Item ID: D205-634-041

Item Name: Replacement Skidtube

DRAWING NO. D2580	TITLE 205 SKIDTUBE ASSEMBLY	REV. E	DART AEROSPACE LTD ENGINEERING ORDER	D.E.O. NO. D2580-E-1	SHEET NO. SHEET 1 OF 1	SCALE NTS
DRAWN <i>UP</i>	CHECKED <i>ASS</i>	MFG. APPR. <i>ER</i>	APPROVED <i>#</i>	DE APPR. <i>#</i>		
DATE 11.12.13	DATE 11.12.13	DATE 11.12.13	DATE 11.12.13	DATE 11.12.13	DATE 11.12.13

CHANGE ALL C'BORED WELDED CROSSBOLT SPACERS TO SWAGED SPACERS

SECTION B-B D5-2
SCALE 5X

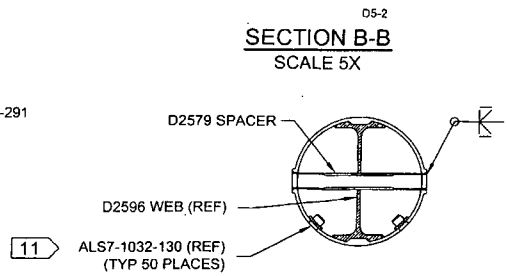
- AFTER DRILLING AND BENDING ASSEMBLY PERFORM THE FOLLOWING FOR Ø0.508 HOLES ONLY:
1. CHAMFER HOLE 0.050 X 45°
 2. INSERT D2579 SPACER (20 PLACES)
 3. WELD INTO PLACE AND GRIND FLUSH
 4. C'BORE D2579 SPACER TO Ø0.437 X 1.00 DEEP

SECTION B-B, F-F, I-I
NOT TO SCALE

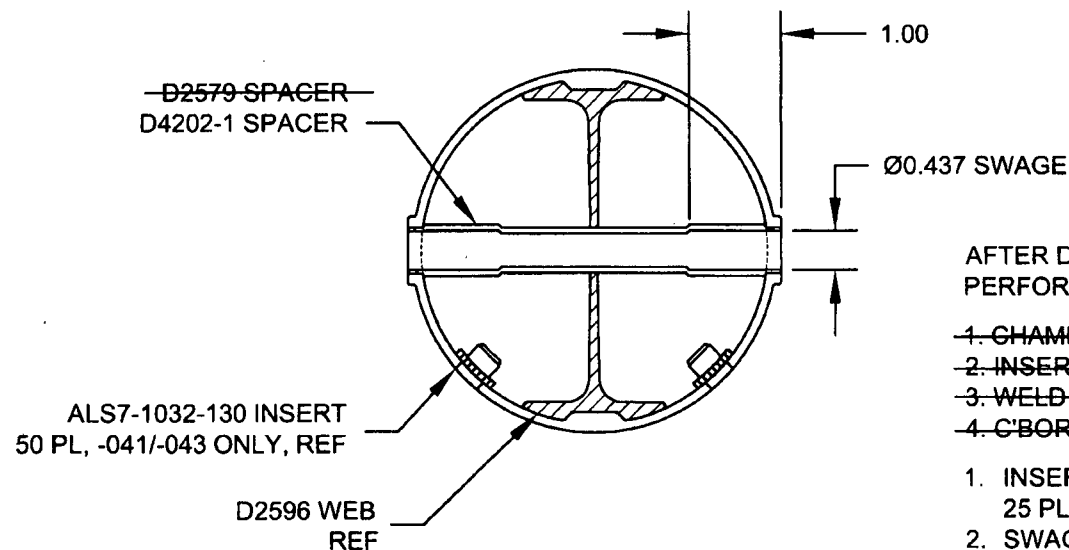
SECTION B-B, SECTION F-F, & SECTION I-I ARE AMENDED AS FOLLOWS
FOR ALL HOLES THAT WERE ORIGINALLY C'BORED:*** FOR -045 SKIDTUBE ONLY:**WELD 4X D2579 SPACERS PER DWG
IN LOCATIONS MARKED "NO C'BORE".
REF SHEET 4 OF DWG.RELEASED
2011-12-14AFTER DRILLING AND BENDING ASSEMBLY
PERFORM THE FOLLOWING FOR Ø0.508 HOLES ONLY:

- ~~1. CHAMFER HOLE 0.060 X 45°~~
- ~~2. INSERT D2579 SPACER (20 PLACES)~~
- ~~3. WELD INTO PLACE AND GRIND FLUSH~~
- ~~4. C'BORE D2579 SPACER TO Ø0.437 X 1.00 DEEP~~

1. INSERT D4202-1 SPACER, 20 PL (-041) OR 20 PL (-045) OR 25 PL (-047)
2. SWAGE TO Ø0.437 X 1.00 DEEP PER QSI 002
3. TRIM / GRIND FLUSH PER QSI 002
